BID No. 2020-021 - ADDENDUM #1

**SOLICITATION OF BIDS
THERMAL REMEDIATION OF VOLATILE ORGANIC COMPOUNDS
FORMER WASTEWATER TREATMENT FACILITY
SARL DRIVE
SALEM, NEW HAMPSHIRE**

Date: January 15, 2021

SEWER INTERCEPTOR AS-BUILT PLANS AND PORTIONS OF GZA SITE PLAN

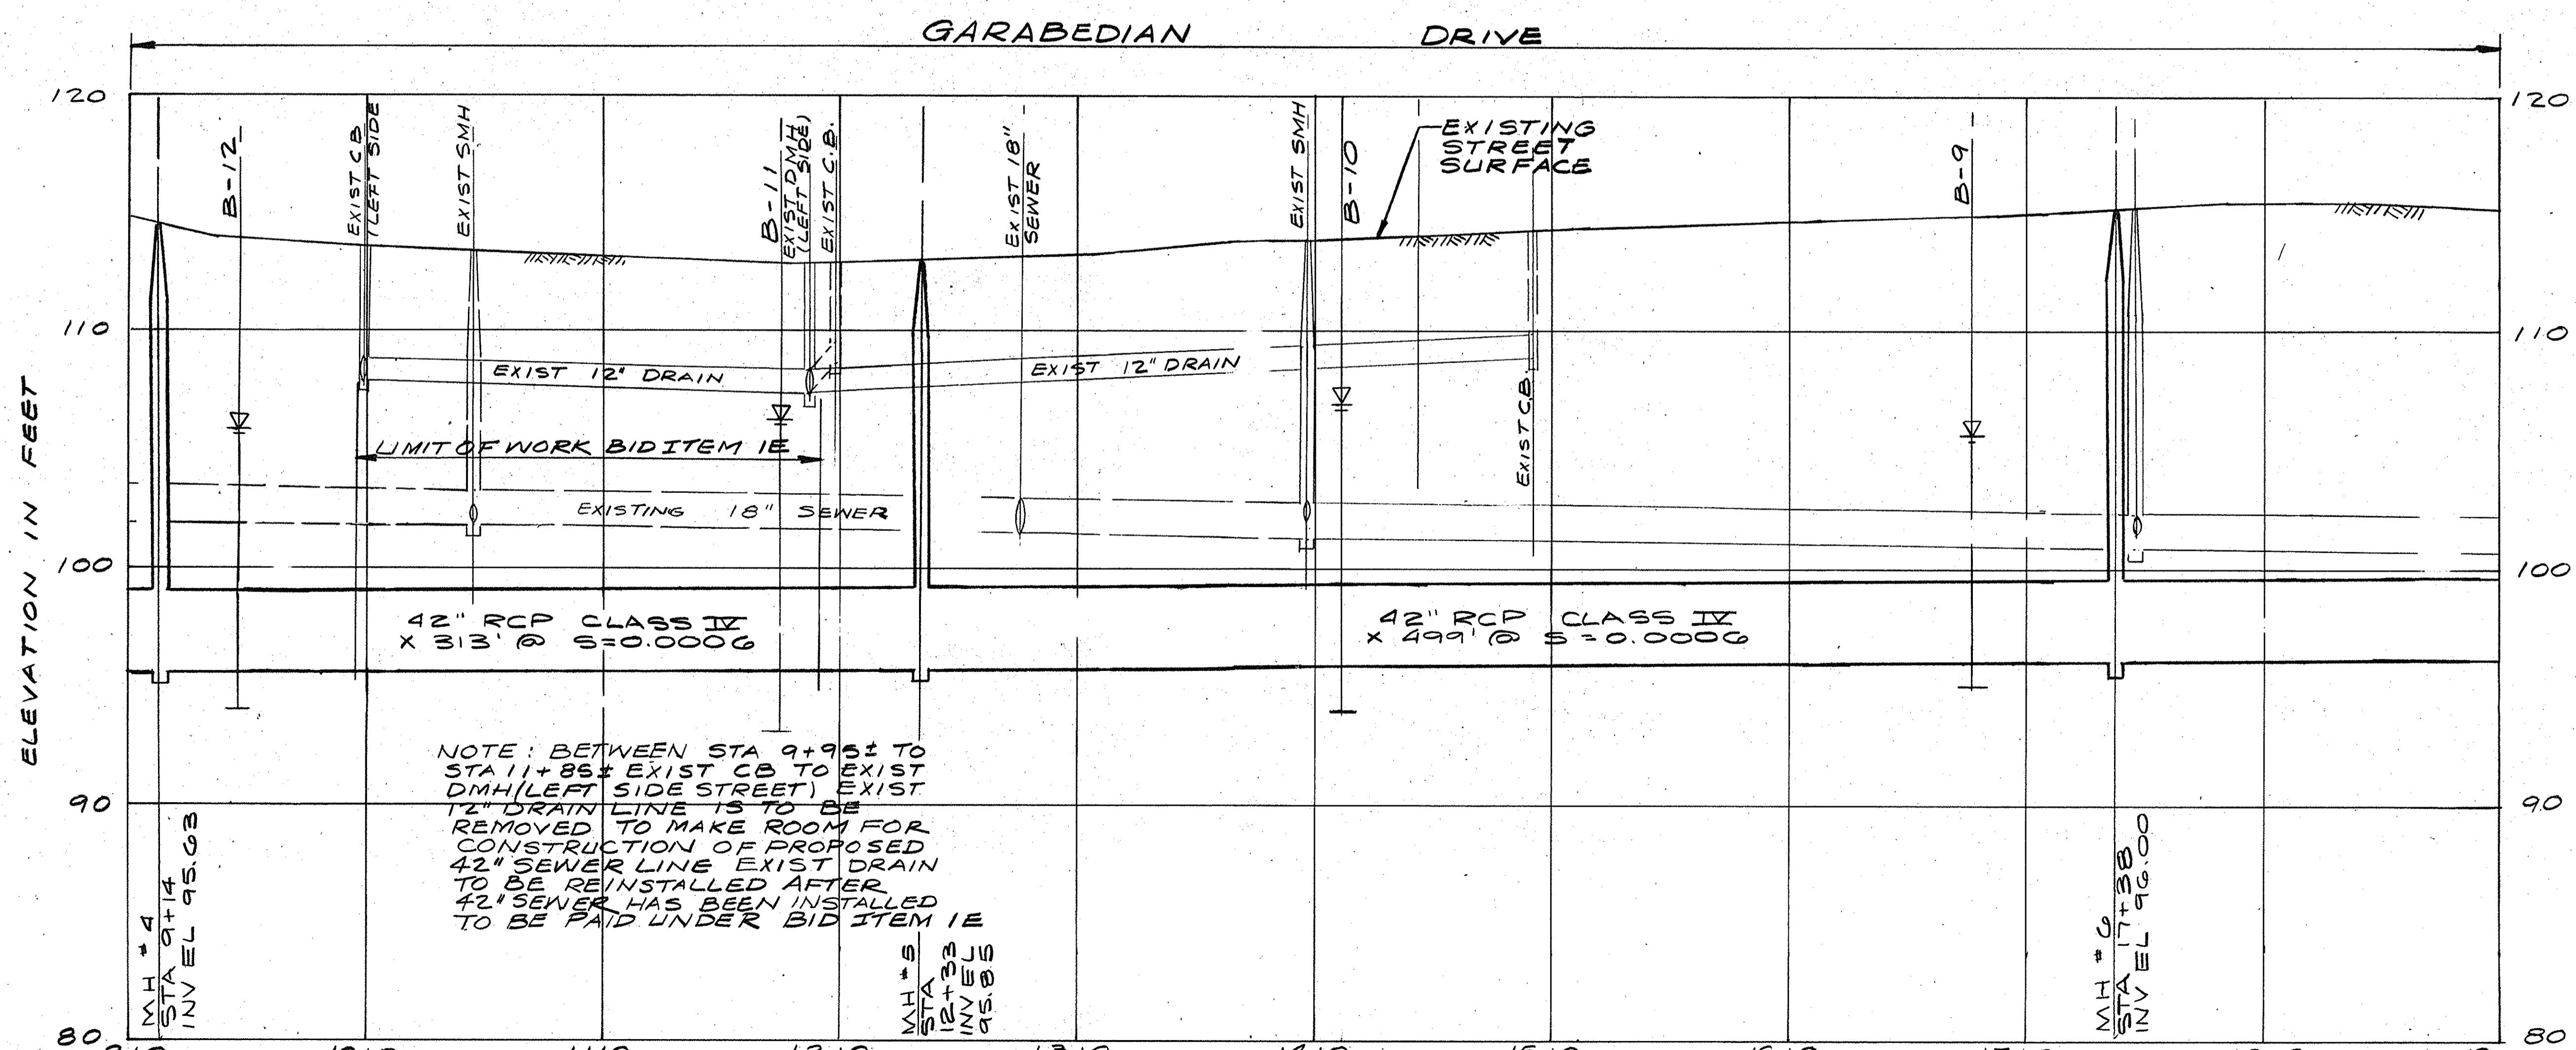
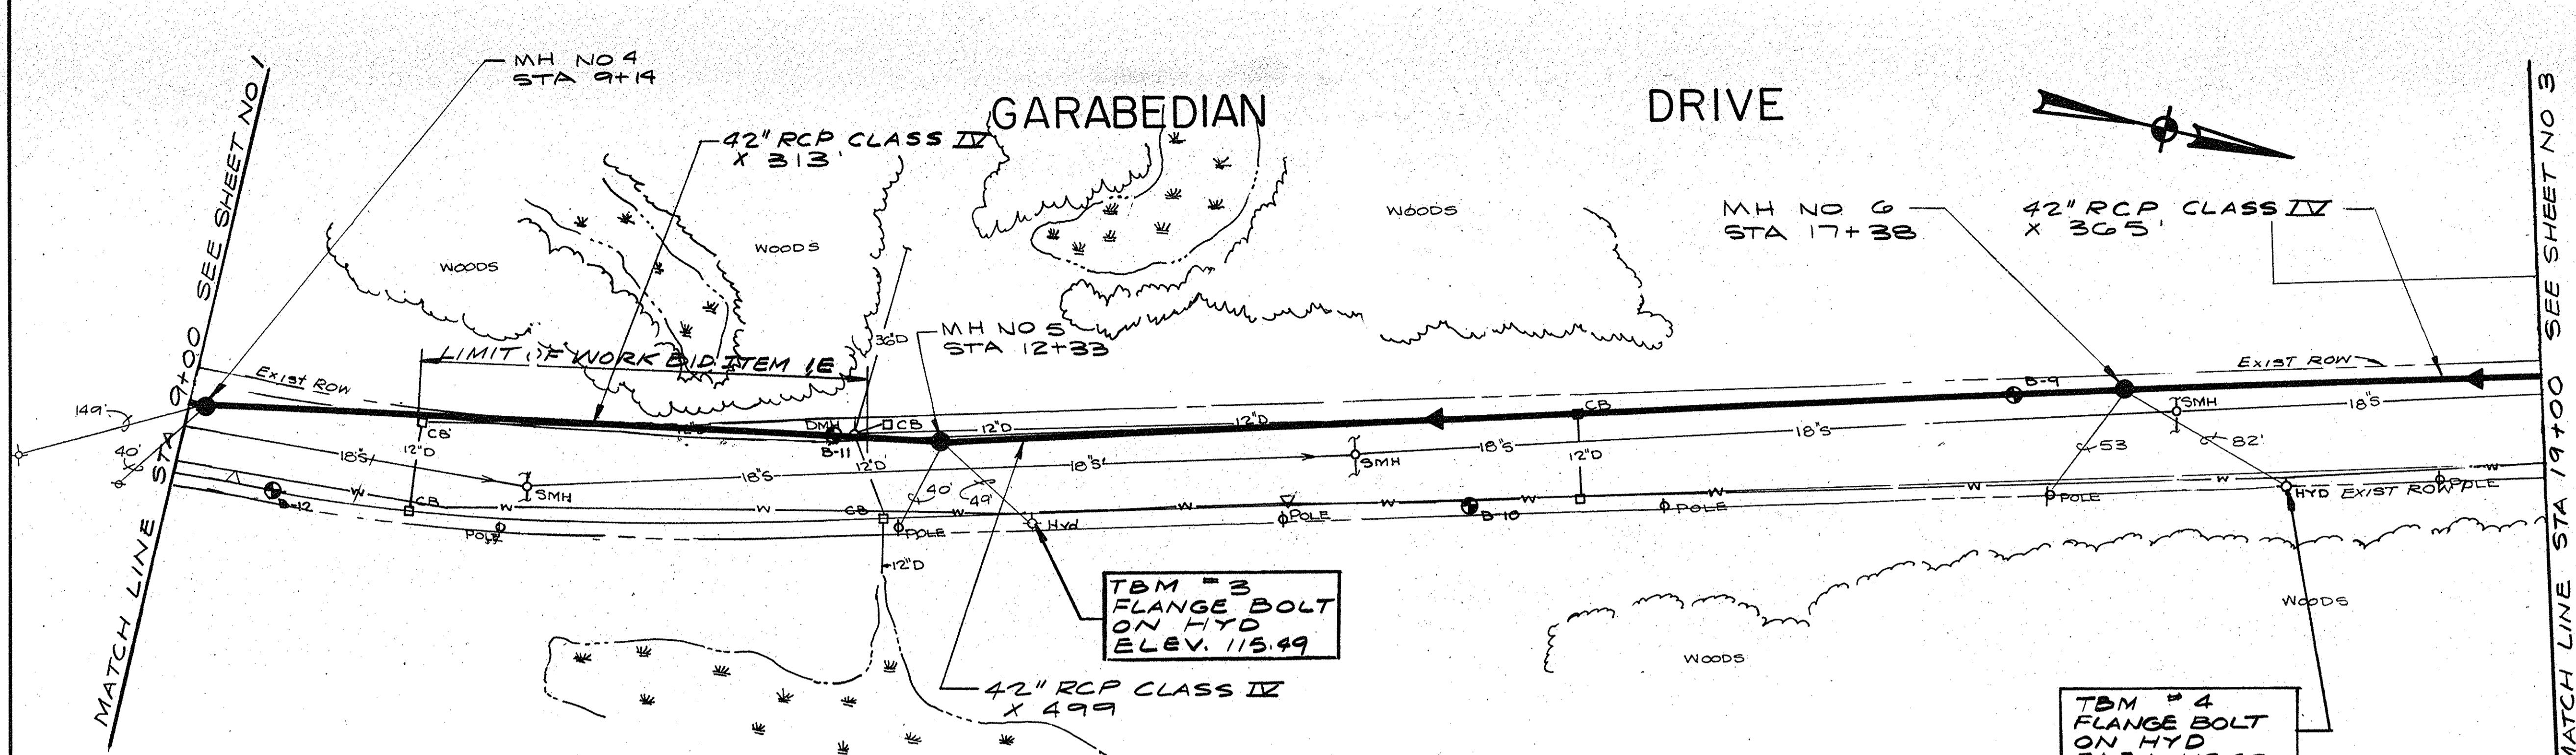
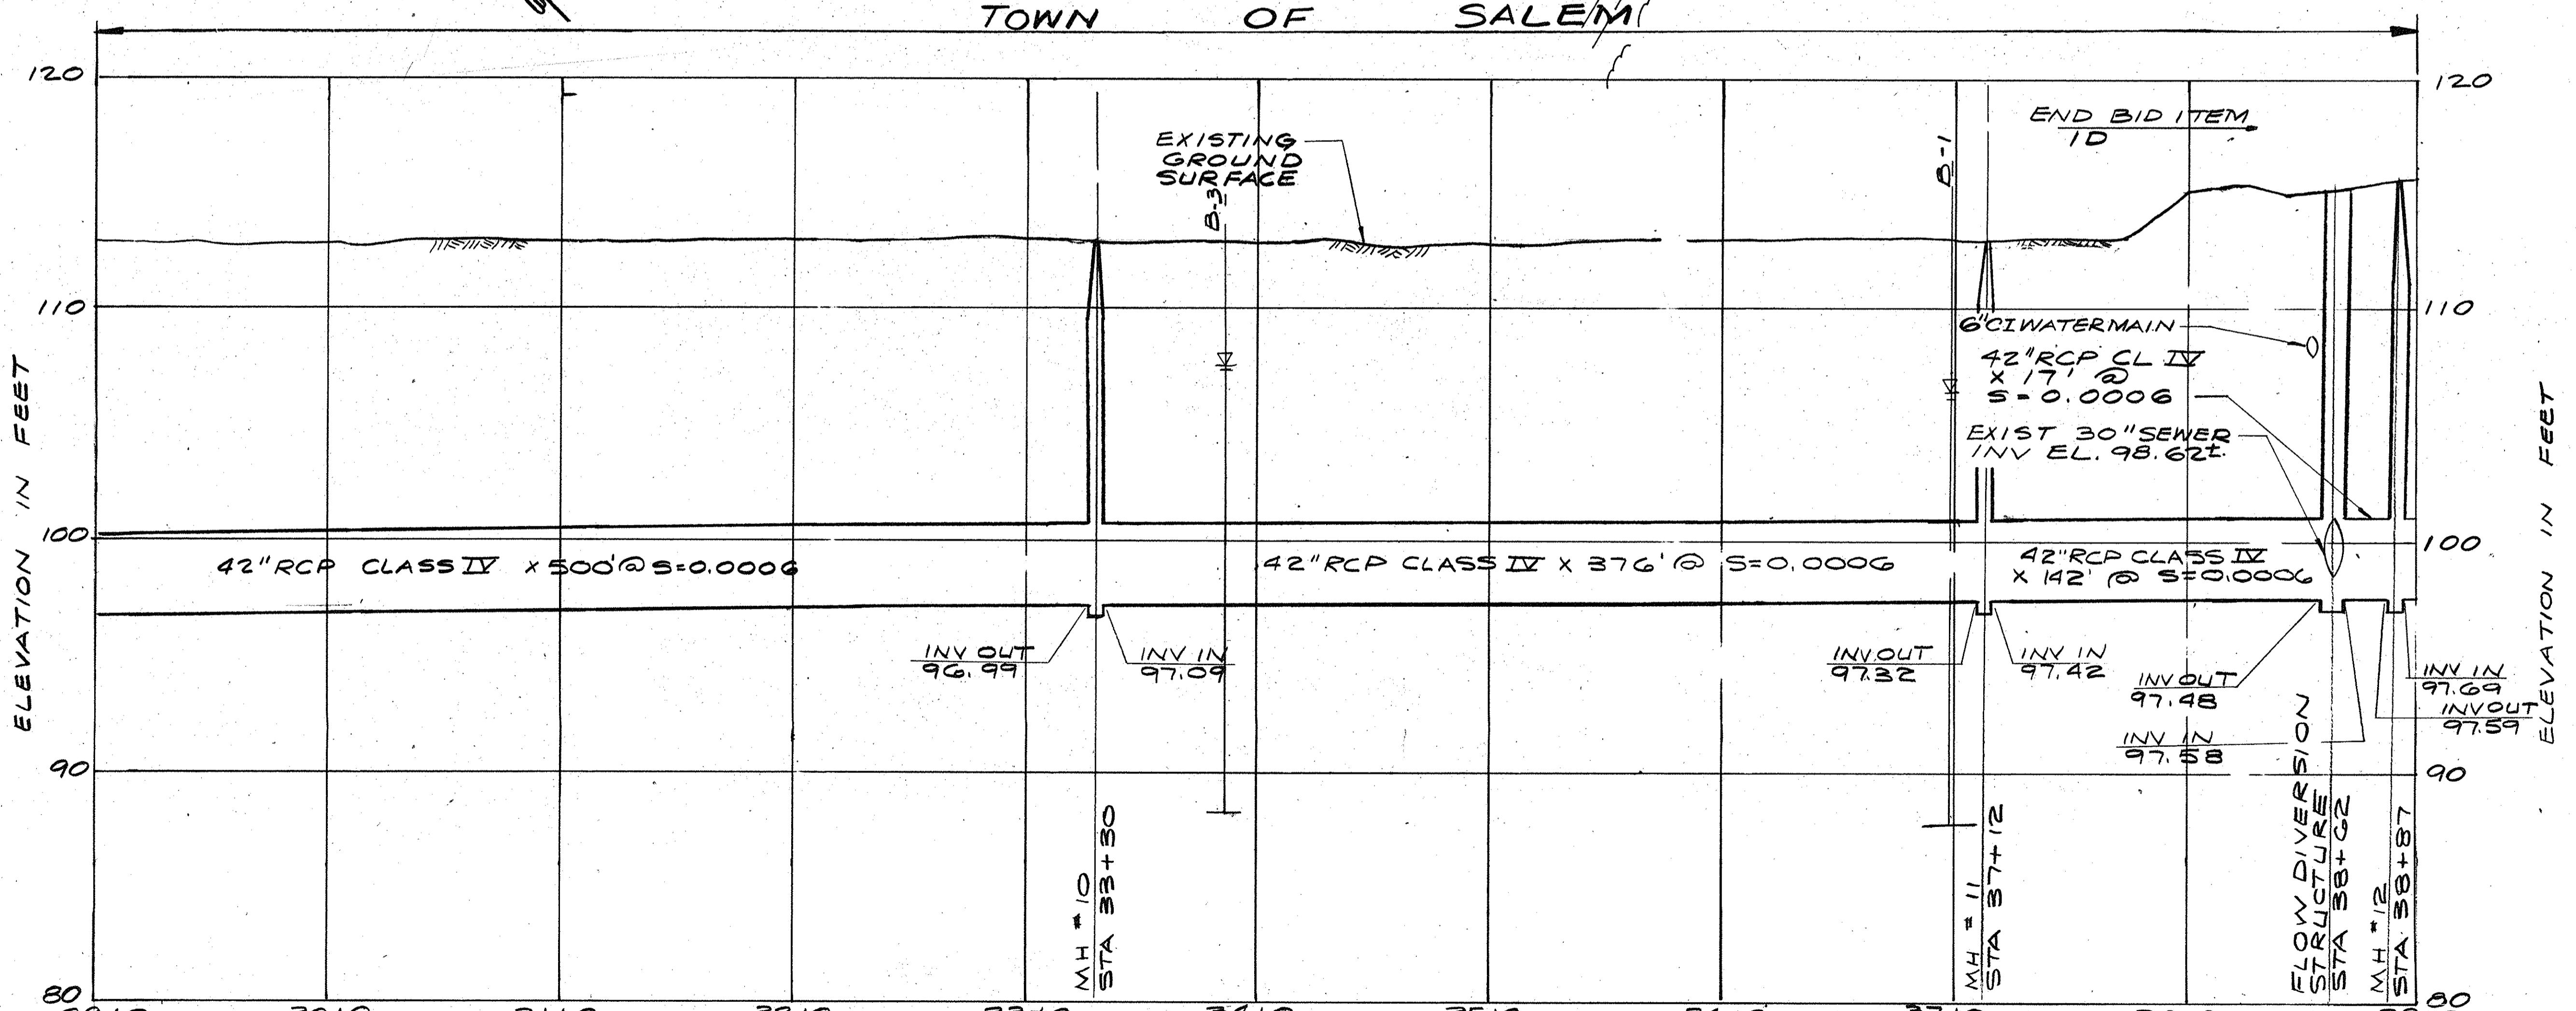
Question: What are the sewer line specifications such as materials, construction details, installation depths, etc?

Response: As-built plans for the 42-inch reinforced concrete pipe (RCP) as presented in Attachment B. Attachment B also include portions of a GZA site plan showing the 42" RCP sewer line.
